2021/1099/L

16 Park Village East, London, NW1 7PX

<b>Delegated Report</b>		<b>Analysis sheet</b>		<b>Expiry Date:</b>	
<b>(Members Briefing)</b>		N/A		<b>05/05/2021</b>	
				<b>Consultation Expiry Date:</b>	
				<b>04/05/2021</b>	
<b>Officer</b>			<b>Application Number(s)</b>		
Alan Wito			2021/1099/L		
<b>Application Address</b>			<b>Drawing Numbers</b>		
16 Park Village East London NW1 7PX			<i>See draft decision notice</i>		
<b>PO 3/4</b>	<b>Area Team Signature</b>	<b>C&amp;UD</b>	<b>Authorised Officer Signature</b>		
<b>Proposal(s)</b>					
Installation of temporary internal secondary glazing to twenty-two windows, one door and five mechanical ventilation unit at the basement, ground floor, first floor and second floor levels of the building for noise mitigation works during construction of the HS2 railway. Works will also include the replacement of existing single glazing within one modern door at basement level to the rear.					
<b>Recommendation:</b>		Grant conditional listed building consent

Photo 4: Proposed drawings showing secondary glazing fitted to reception room windows

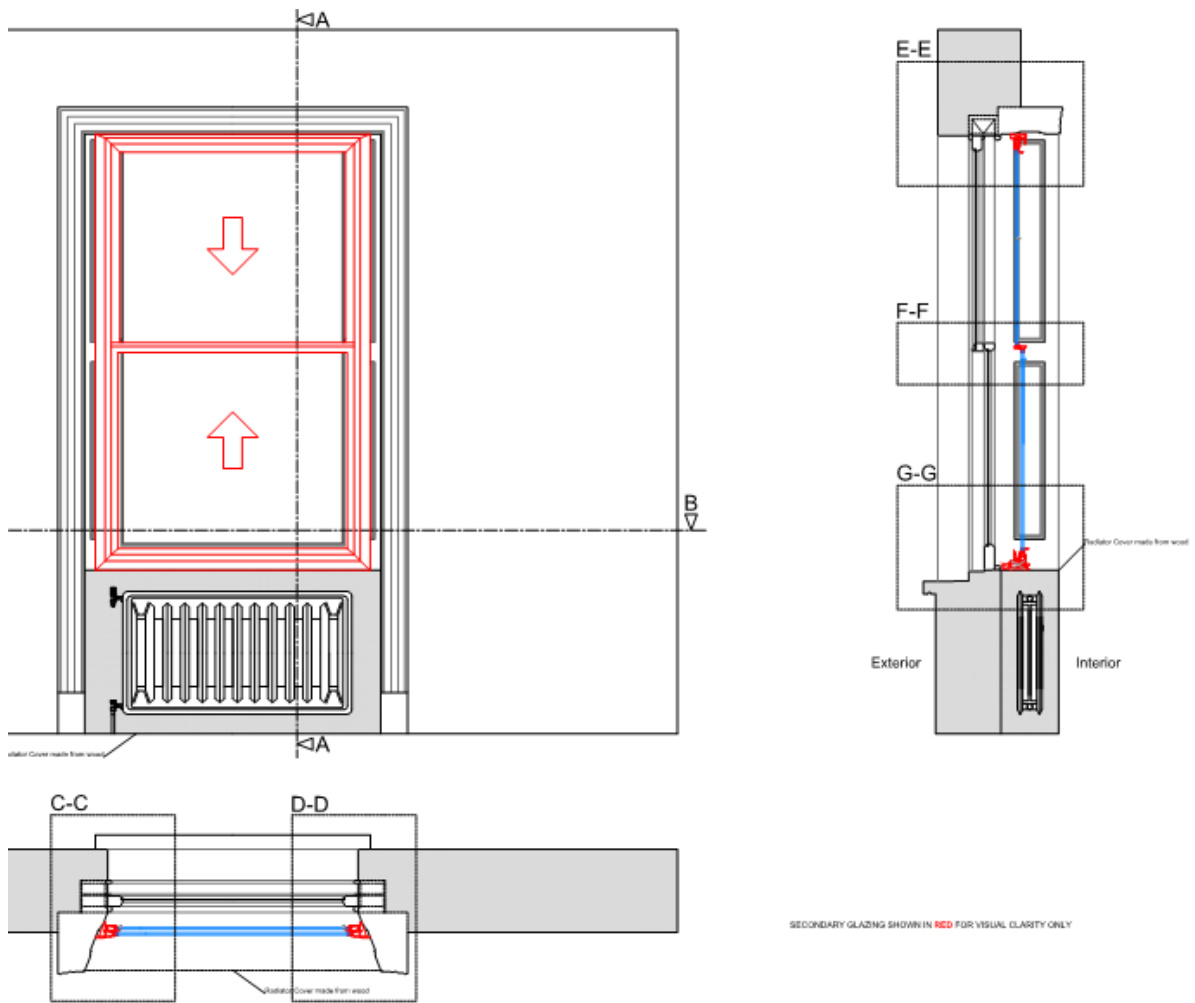
- 3.5. In light of Regent's Park CAACs objection to the proposal for the ground floor front room windows other options were investigated which avoided mounting the secondary glazing on the window shutters. Mounting the secondary glazing closer to the outer window would result in a sub optimal acoustic performance as the gap would be well below the 100mm minimum which is needed. The alternative would be to mount the secondary glazing further away from the external window but this would then cover over the vents for the radiator and mean that the room would not be efficiently heated and construction noise could bypass the secondary glazing through this vent.
